Newell Boathouse Renovations

Notice of Intent – Supplemental Information

April 27, 2022

Formal Response to Hearing Comments

FIGURE 2

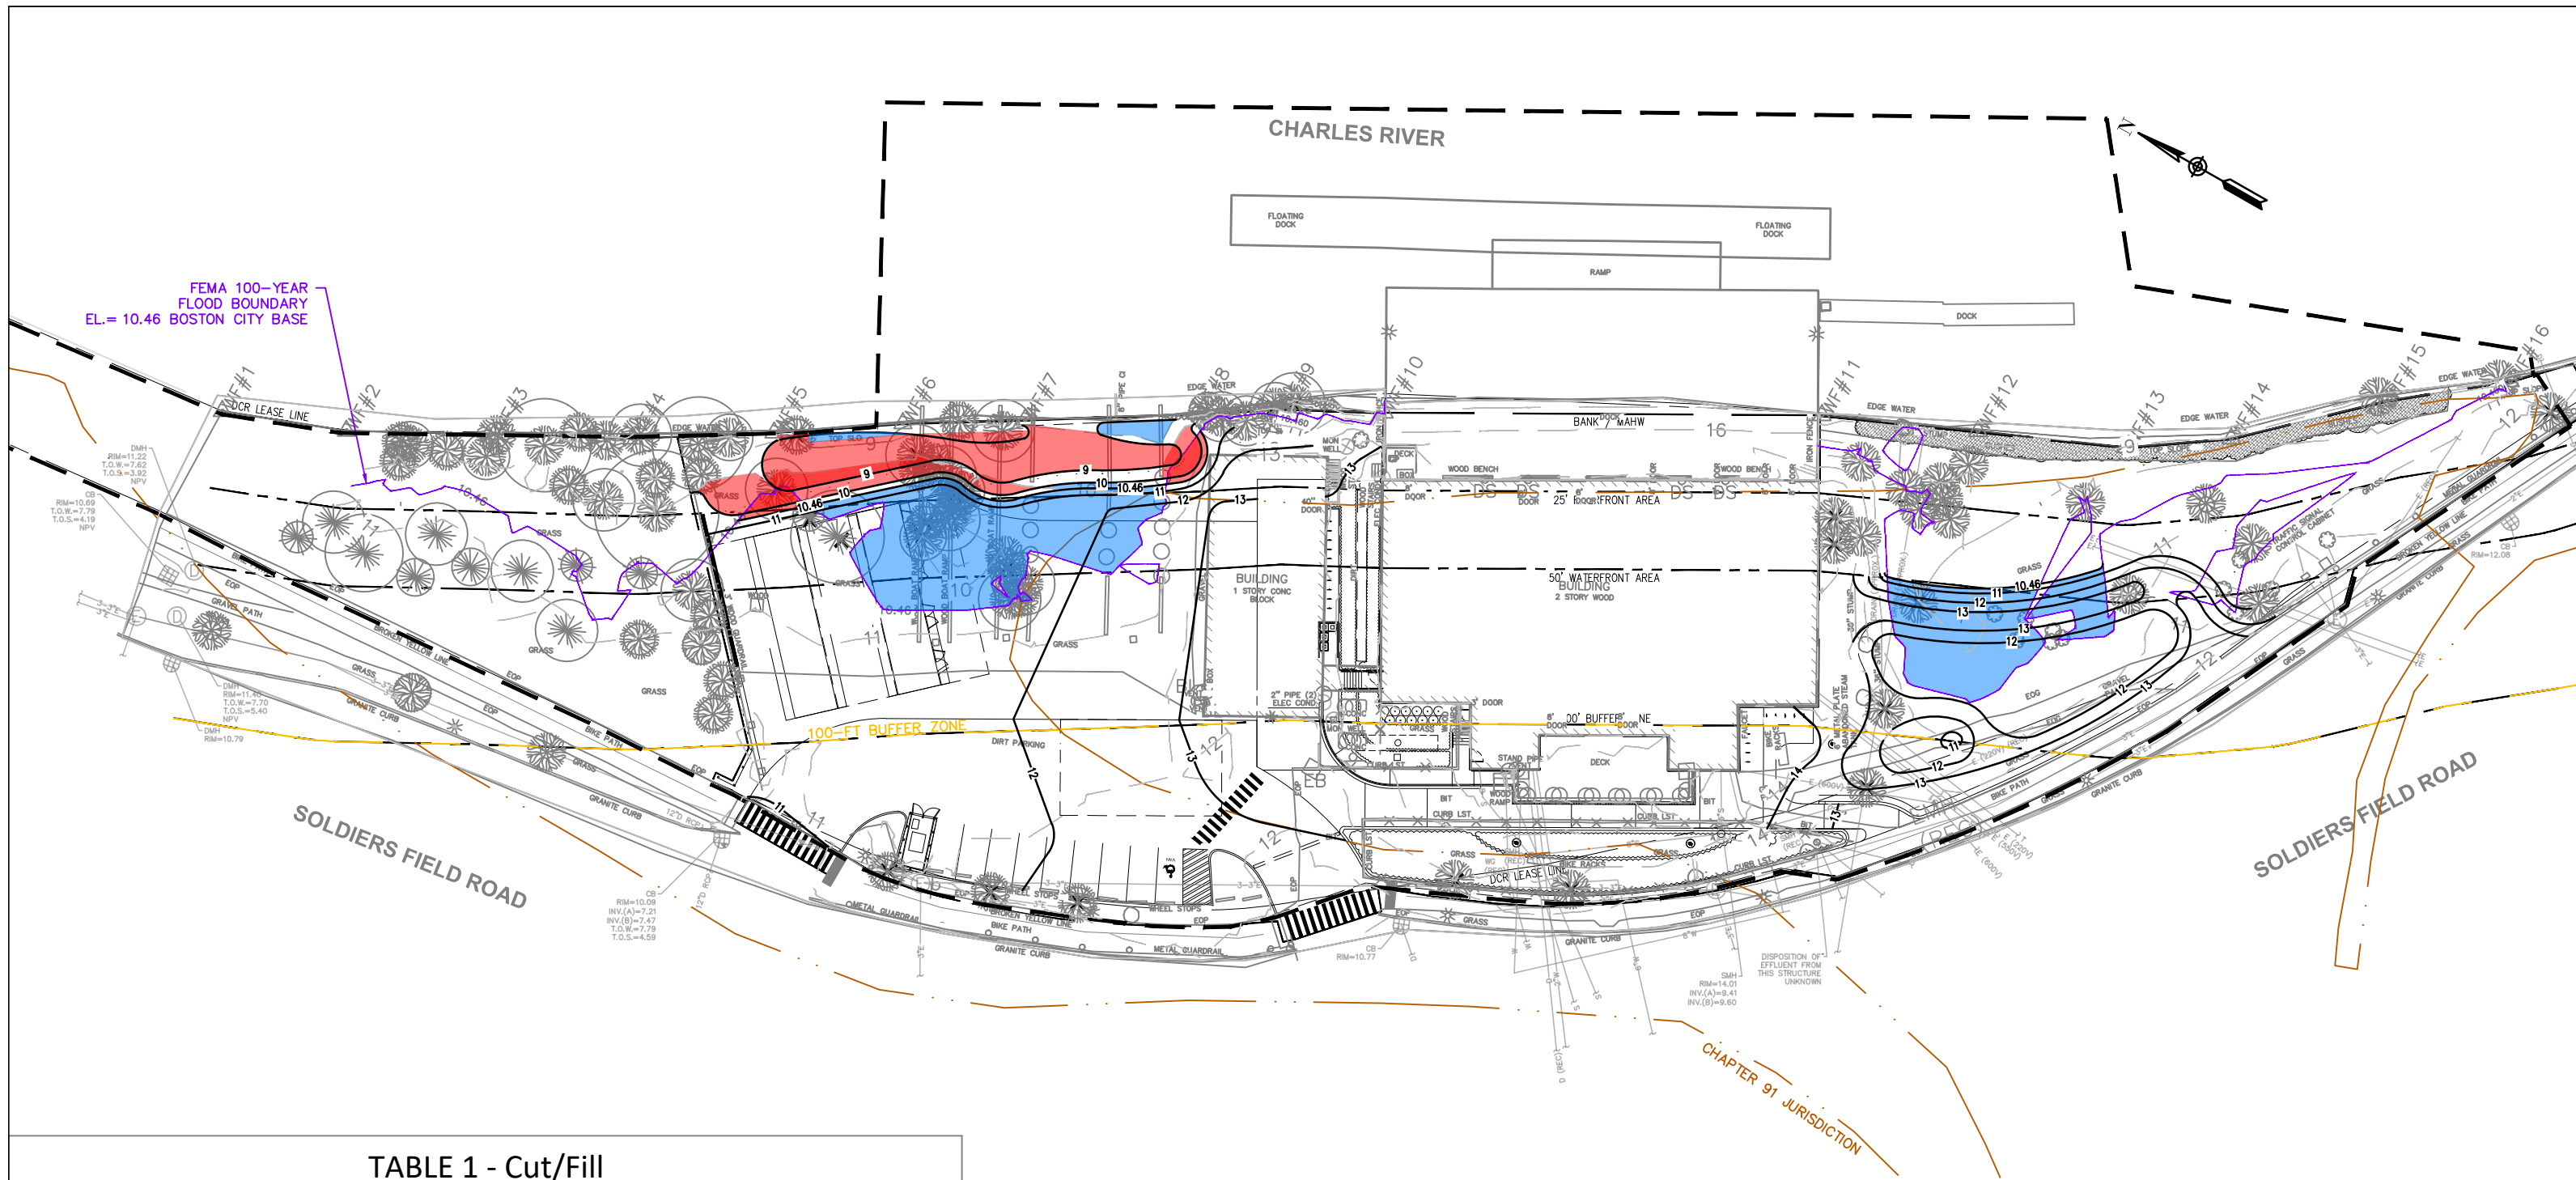
Item	Comment	Response	Att
1	The Notice of Intent indicates that the project will alter 13,705 sqft of BLSF and 2,033 cu ft of flood storage will be lost as a result. 310 CMR 10.57(4)(a)(1) states "Compensatory storage shall be provided for all flood storage volume that will be lost as the result of a proposed project within Bordering Land Subject to Flooding, when in the judgment of the issuing authority said loss will cause an increase or will contribute incrementally to an increase in the horizontal extent and level of flood waters during peak flows." In response to how this performance standard is being met, the NOI provides only a qualitative statement. In other instances where work has proposed a loss of flood storage in such urbanized areas of the city, the Commission has requested a Hydrologic and Hydraulic (H&H) Study be performed and submitted to substantiate the claims that there will be not be an increase in the horizontal extent and level of flood waters during peak flows	The design team reviewed the site further and has expanded the swale to ensure that no flood storage volume has been lost within Bordering Land Subject to Flooding. We have attached the revised figure showing the cut and fill volumes as well as the updated plans with the larger swale.	A, B

16	The value for compensatory flood storage stated at the hearing was substantially less than the value stated in the Notice of Intent. Please clarify this as well.	We have updated the cut and fill figures as part of ensuring no flood storage is lost. The revised figures are attached.	B
17	Staff also wants to touch base with the project team, specifically about the restoration/mitigation components of the project and how they comply with the Riverfront Area performance standards. This can happen at any time before the next hearing.	We met with Staff on Monday (4/25) to review the Riverfront Area, our Supplement Information submittal includes the results of that conversation about the mitigation in the RA.	C

Figure 1 - Option 2

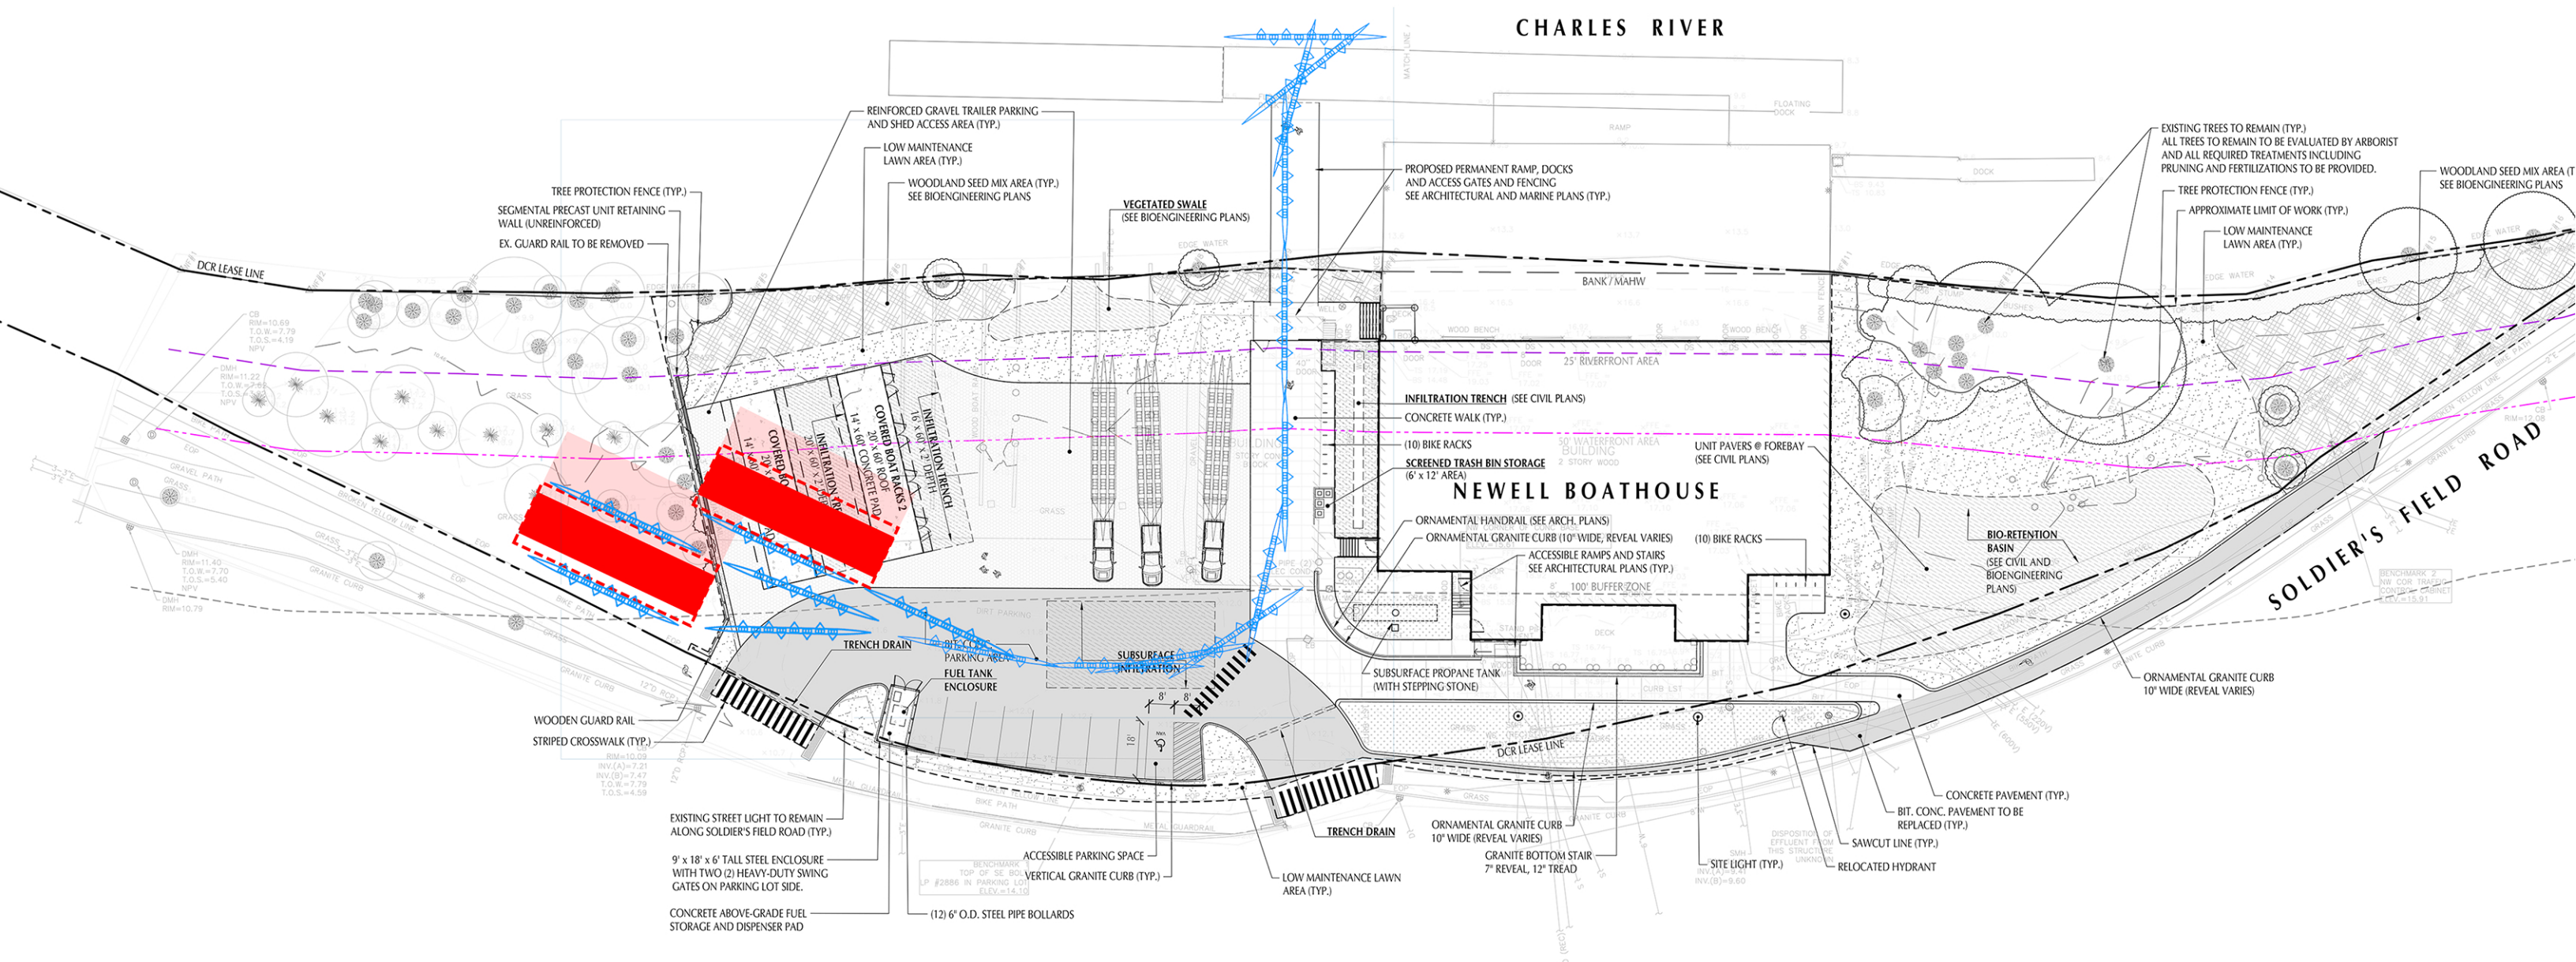
Item	Comment	Response	Att
11	What is the total change in impervious surface cover within each resource area?	<p><u>25' Riverfront area</u>: net reduction of 379 sf of impervious area</p> <p><u>50' Waterfront</u> (includes area within 25' Riverfront): net increase of 120 sf of impervious area</p> <p><u>100' Buffer</u> (includes area within 50' Waterfront and 25' Riverfront): net increase 1,721 sf of impervious area</p>	-
12	To this date, the Commission has not allowed a structure to be constructed in the Waterfront Area. What other locations were considered for the boat racks, and how was the proposed location settled on?	The design calls for an existing structure that is located in both the Riverfront Area and Waterfront Area to be removed and replaced by two smaller covered boat racks that are also further back from the river and out of the Riverfront Area. We have attached a specific alternatives analysis detailing more of the design input that went into the decision for the current location.	F

Another option that was considered and was also asked for us to show by the Commission, was the relocation of the covered boat racks (see Image 2) outside of the Waterfront Area. This involved removed the existing structure in the riverfront and waterfront area and replacing it with two smaller covered boat racks. Both the design team and DCR liked the idea of removing the existing building and providing smaller, more open and easily assessable boat racks, that could be located further back from the river with a more minimal footprint. In early planning having it located further back from the river had been considered but one of the key points brought up during our reviews with DCR was to try and minimize the amount of disturbance in the overall resource area and limit the amount of tree removal. A key marker is the existing timber barrier along the edge of the site that was identified as something we should stay within. As can be seen in the attached drawing, there would need to be additional trees removed and more disturbance created in order to be able to accommodate the covered boat racks. Therefore, this option was not used and the goal was to keep them within the currently defined project limits. See Figure 1 for a graphical representation of this option. It should also be noted that the DCR was very concerned with limited space on this site and at
